RHODE ISLAND CONTRACT NO.2014-CI-075

**Providence Station Enhancements**

NOTICE TO PROSPECTIVE BIDDERS

ADDENDUM NO. 2 Prospective bidders and all concerned are hereby notified of the following changes in the Plans, Specifications, Proposal and Distribution of Quantities for this contract. These changes shall be incorporated in the Plans, Specifications, Proposal and Distribution of Quantities, and shall become an integral part of the Contract Documents.

**SITE PREPARATION PLAN NO. 1**

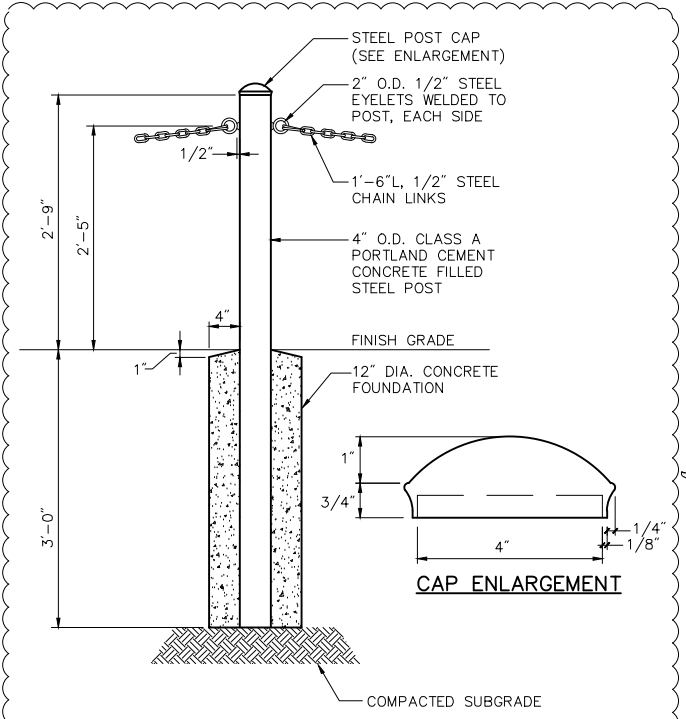
Delete Site Preparation Plan No. 1 and insert the revised Site Preparation Plan No. 1 (R-1) attached to this ADDENDUM NO.2. Bollards with chains adjacent to the Gaspee Street widening are now called out to be removed and disposed.

**STEEL BOLLARD WITH CHAIN**  
NOT TO SCALE

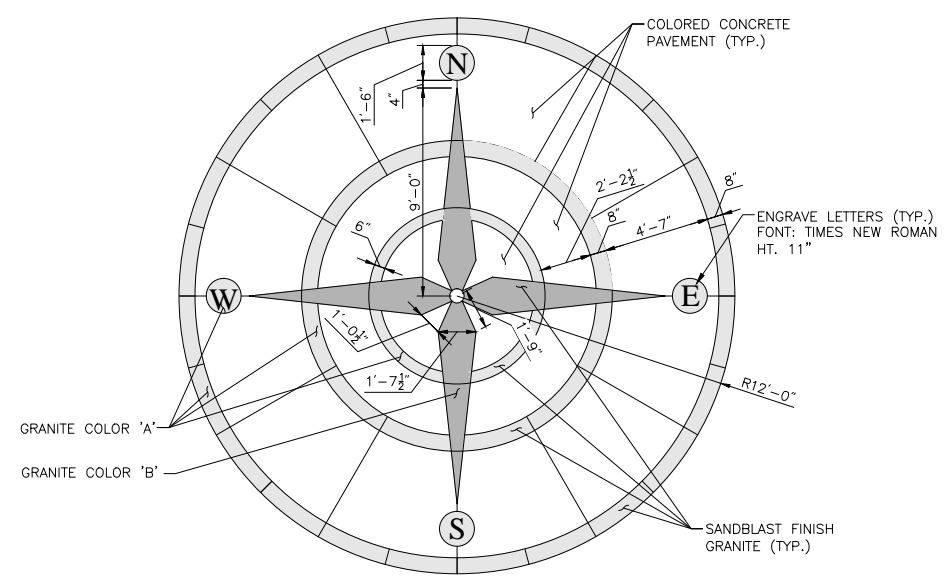
Delete Detail Sheet No. 3 and insert the revised Detail Sheet No. 3 (R-1) attached to this ADDENDUM NO.2. Steel Bollard with Chain detail has been added.

- NOTES:**
1. PRIME AND PAINT BOLLARD POST AND CAP WITH APPROVED EXTERIOR METAL EPOXY BASED ACRYLIC PAINT.
  2. COLOR TO BE GRAY TO MATCH EXISTING SURROUNDING POST BOLLARDS.

**TYPE A**  
**WALL MOUNTED ORNAMENTAL STEEL FENCE—24" HIGH**  
NOT TO SCALE

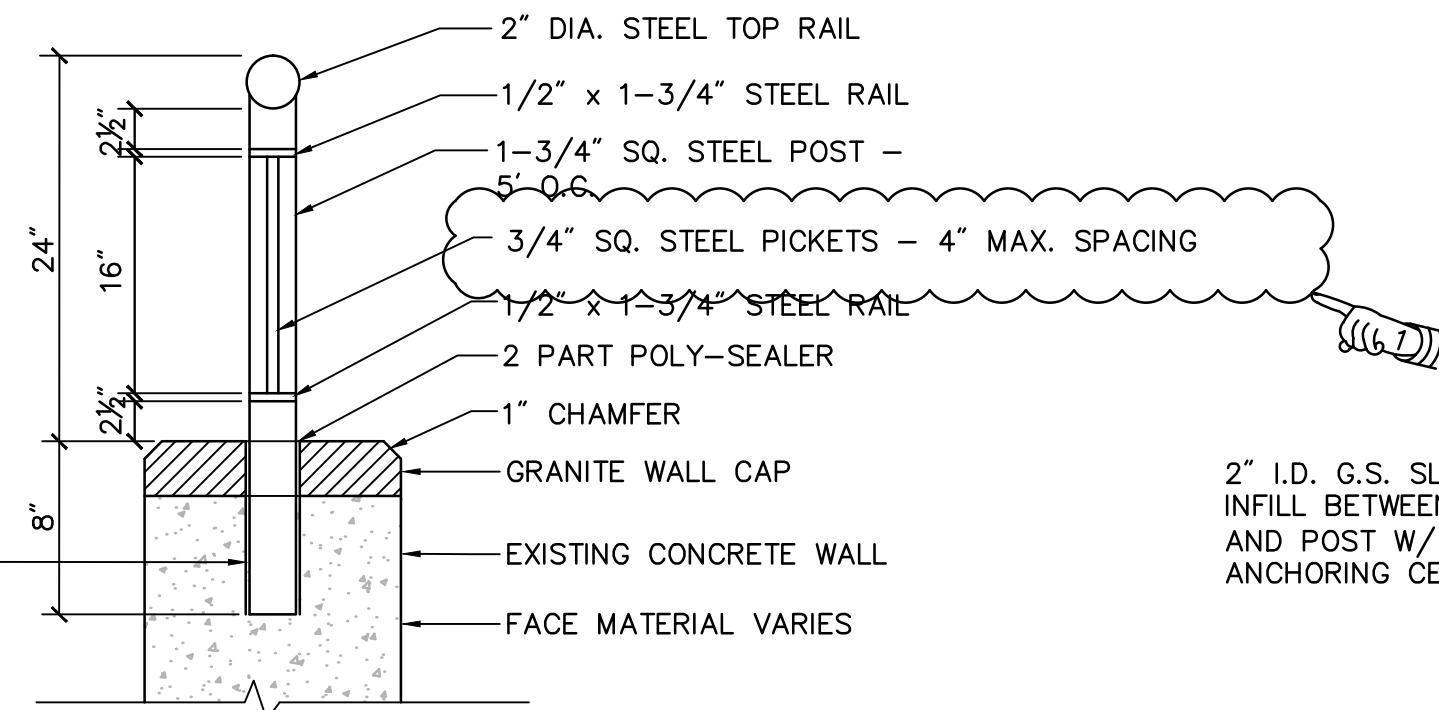
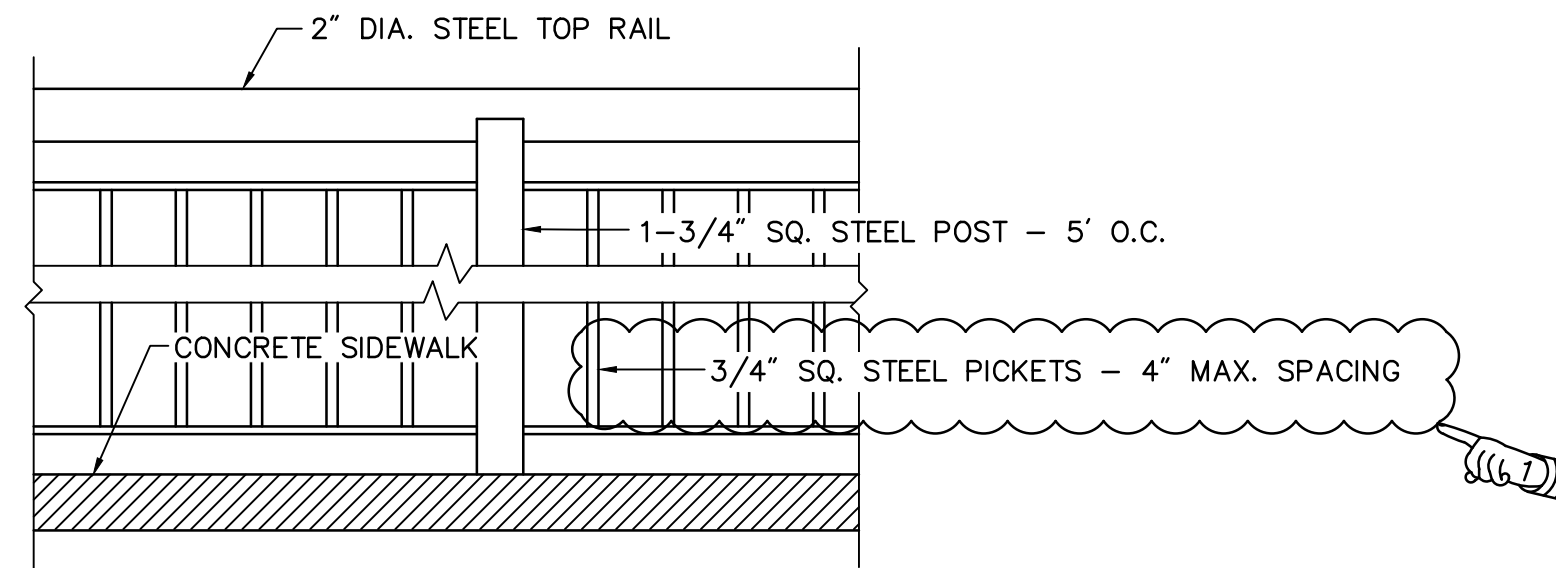
Delete Detail Sheet No. 4 and insert the revised Detail Sheet No. 5 (R-1) attached to this ADDENDUM NO.2. Picket spacing has been added to the details for Ornamental Steel Fence - 24" High and 42" High.
